Development Permit Panel

MINUTES

1. DEVELOPMENT PERMIT 18-829233
(REDMS No. 6710093 v. 1A)

PROPERTY LOCATION: 10671, 10691, and 10751 Bridgeport Road

SHEET TITLE	
CURVED FLASHING & FURRED EXT WALLS DETAIL (BLDG 1 & 8)	
DRAWING	
A4.1

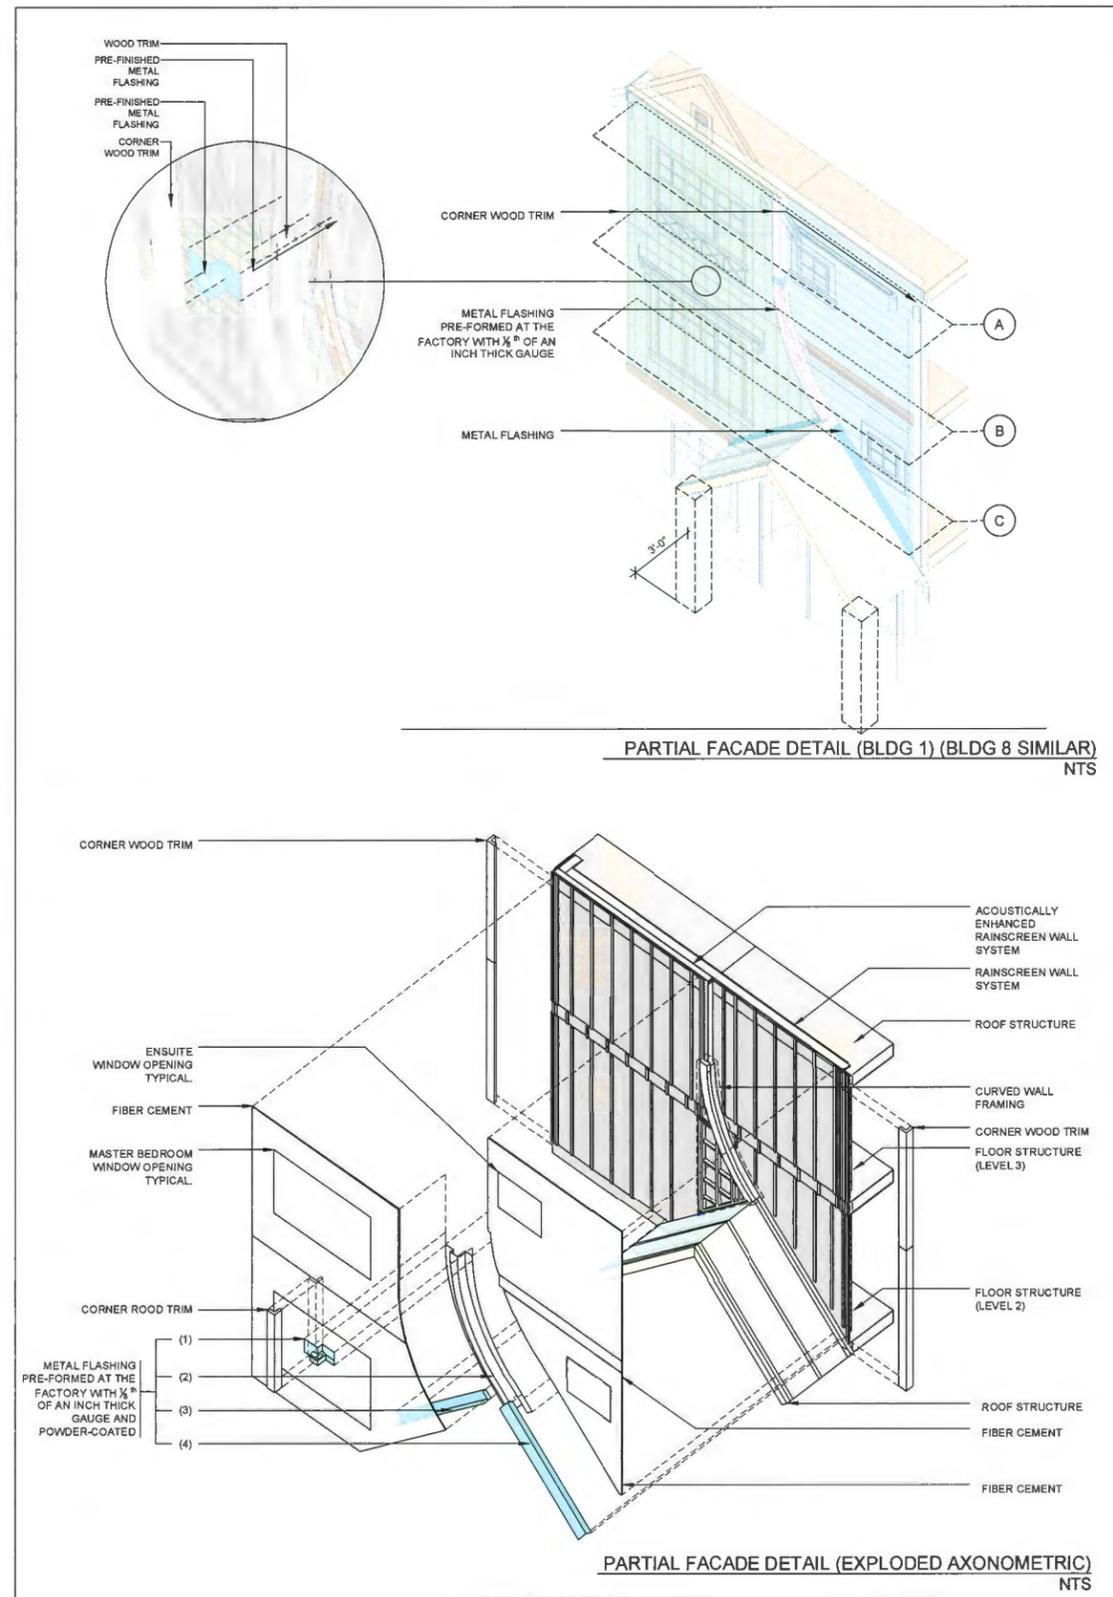
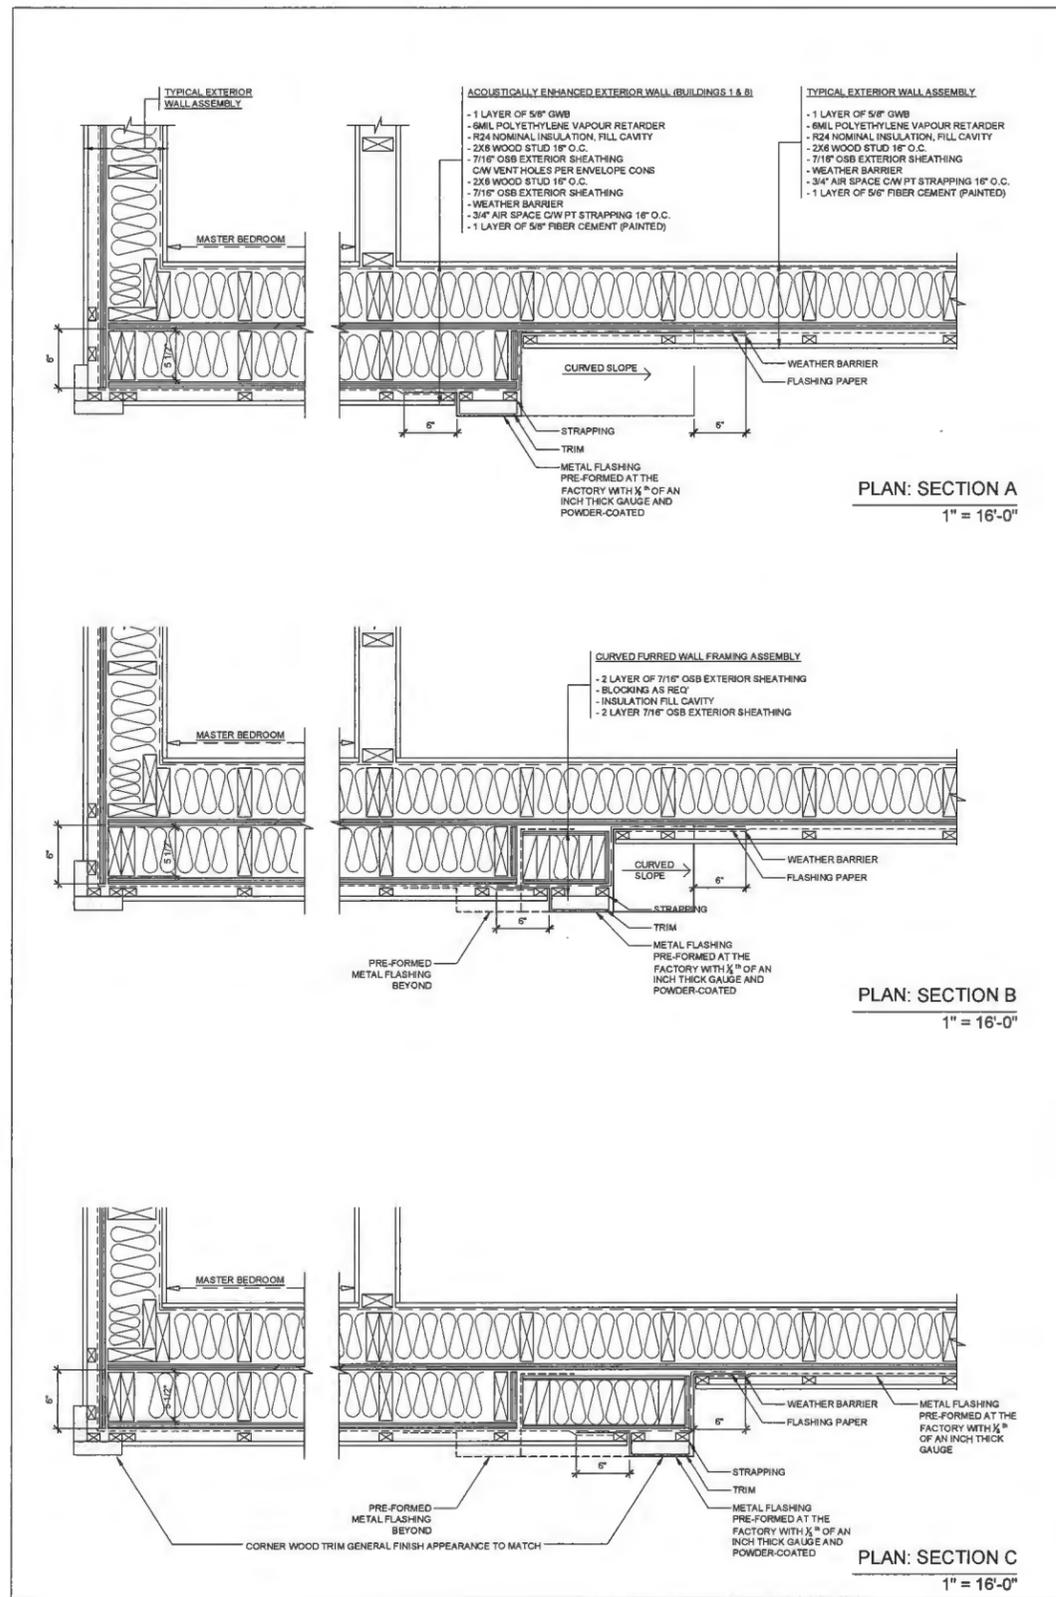
- reconsider the curved shallow furred out portions of the front facades as these appear forced and could give rise to detail issues; *The detailing of the curved furred out portions of the front facades of Buildings 1 & 8 has been revised and reviewed by the envelope engineer. The top of the furred out portions are now protected by pre-made metal flashing instead of roof shingles. Furthermore, the furred portions were made slightly thicker (from 3 ½" to 6"). The curves are an architectural device that helps unify the front façade of Buildings 1 & 8, and provides motif that is used (to a lesser extent) to create an identity to the 3 rows of buildings. The intent is for the curved flashing to be dimensioned and painted to match the exterior corner trims of the cement board cladding.*

- support the proposed curvilinear piece on the front facades which is a clever move; however, the vertical Hardie cladding furred out 3 ½ inches proud of the horizontal siding is not enough; consider adding more depth to at least 18 inches to create a more attractive building elevation and to avoid detailing issues over the long term; *Ideally, an increased depth is preferred, however the front yard setback was increased well into the project design, and limited our building depths. The detail has been finetuned, both visually and technically, and the furred out portions were made slightly thicker (from 3 ½" to 6").*

UNIT Ac BEFORE CONVERSION
SCALE: 1/4" = 1'-0"

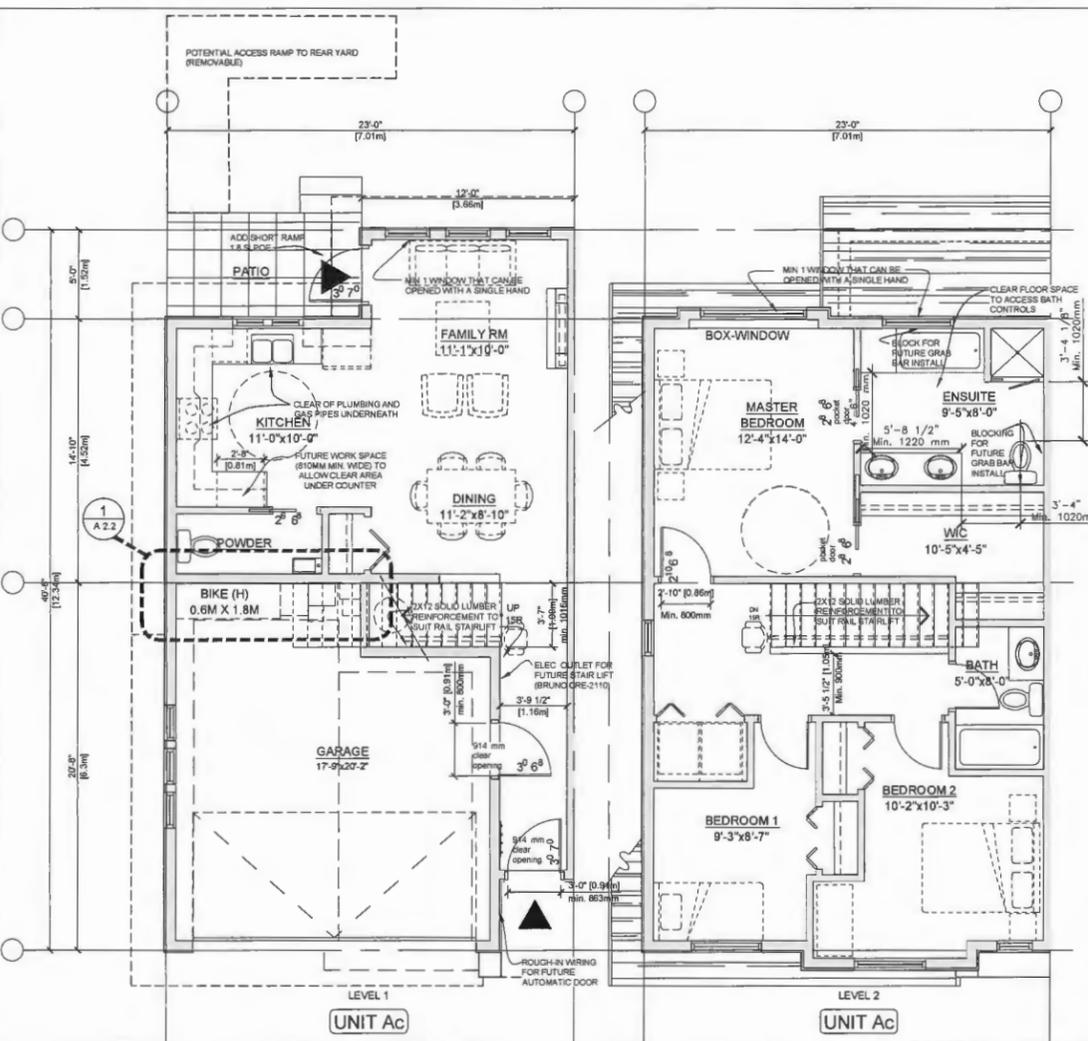
- consider installing an outward swinging door with the hinge on the right side of the garage door entrance to provide more accessibility; *The door swings into the unit from the garage in Unit Ac have been retained because an outswinging door may conflict with the parking space. The swing (i.e. hinge at front door side) would presumably aid access from the garage to the interior of the unit.*
